Representation Form

A27 Chichester Bypass Mitigation Supplementary Planning Document Consultation

The document as a whole – all sections

Figure 1
Proposed Mitigation at A259 Bognor Road/A27 Roundabout and Vinnetrow Road Link

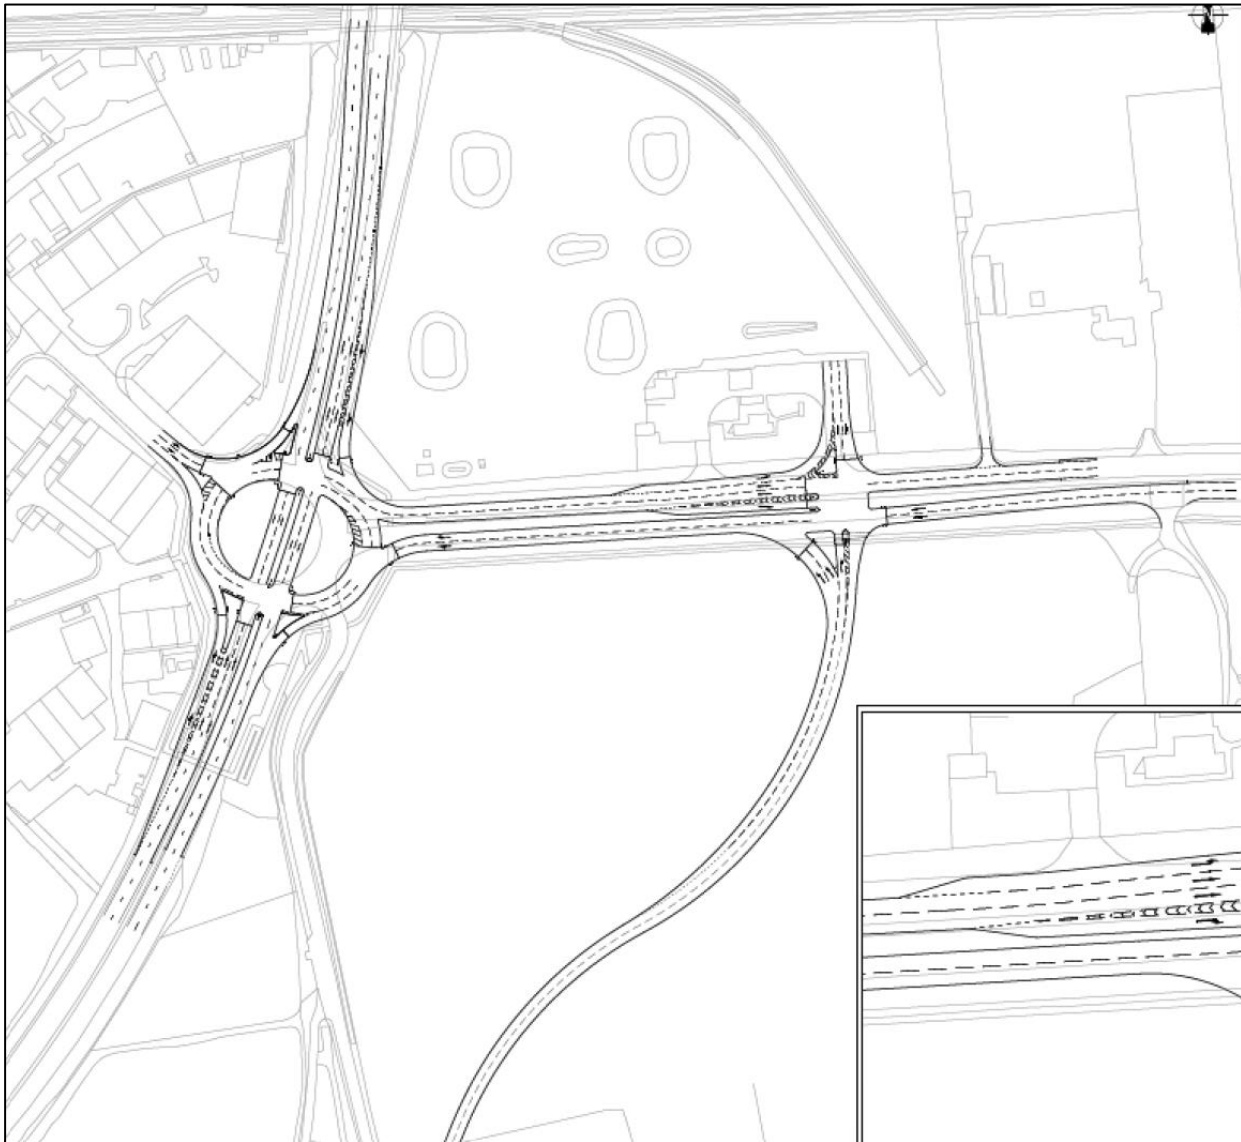
Section 4 of the Bypass Mitigation SPD refers to the Local Plan Transport Assessment (Stantec, January 2023) which includes the mitigation proposals at the A259/A27 roundabout, with an extract shown at Figure 1 below. We would note that this plan is from 2018.

There is **no mention of any sustainable infrastructure, such as footways or cycleways** to be included in the proposals.

Chapter 6 of the Chichester Transport Study refers to consideration of sustainable mitigation measures which includes reference to walking and cycling, and public transport. However, the proposed mitigation at the A259 Bognor Road/A27 junction and Vinnetrow Road does **not** include any sustainable transport infrastructure, and although all works at the A259/A27 roundabout are within the public highway, it appears that there is insufficient space within the public highway to provide any form of standard footways and/or cycleways and it appears that the existing pedestrian and cycle overbridge may be removed.

In relation to the above, WSCC are particularly likely to prioritise proposals entailing improvements to the A259 that focus on sustainable transport, including bus travel. The Bypass Mitigation SPD proposals do not include infrastructure for sustainable transport, **i.e. no footways or cycleways, or bus lanes**, and hence they fundamentally **conflict with WSCC's priorities**.

From the figure above, beyond the failure to provide improvements for pedestrians, cycles or buses, no land within the public highway has been safeguarded for such measures. In this respect, the Bypass Mitigation SPD not only fails to deliver sustainable transport, but could actively work against future achievement of these goals, by occupying land that could be used in that more positive way.

The mitigation works proposed in this Bypass Mitigation SPD as shown above **do not safeguard land to provide cycle infrastructure** as set out in the draft West Sussex LCWIP. Hence the proposed Bypass Mitigation SPD is contradictory and unacceptable.

Given that the proposed mitigation at the A259/A27 junction does *not* include measures to improve community connectivity, as the proposals give priority to vehicles on the A27, and not those who use the strategic route between Chichester and Bognor Regis, the proposed SPD is unacceptable.

Furthermore, as the proposed mitigation at the A259/A27 junction also does not include measures to improve public transport accessibility, with no mitigation included to provide bus priority measures, again counter to the draft Bypass Mitigation SPD.

It is considered that to provide a junction which aligns with the local and national policy in terms of sustainable transport infrastructure, the A259/A27 junction should include a package of multi-modal highway improvements, including pedestrian, cycle and public transport infrastructure. This would promote more sustainable travel patterns and encourage increased use of sustainable modes of travel.
